## Product Change Notification

**1. ECR #:** 24-12560-1  
**Notification #:** 746

- EBCF - EXAMAX BACKPLANE CABLE

**4. Part #'s Affected**

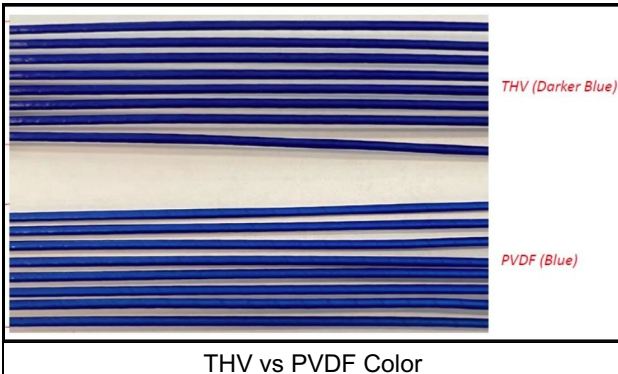
Revised product will use cables with PVDF jacket material instead of THV material. This will be a rolling change as existing THV inventory is depleted.

Revised product can be identified visually by a lighter shade of blue.

- Form - No dimensional changes, weight change from 1.723 to 1.673 lb /1000ft\*, color change as described in Section IV. Method of Identifying Change
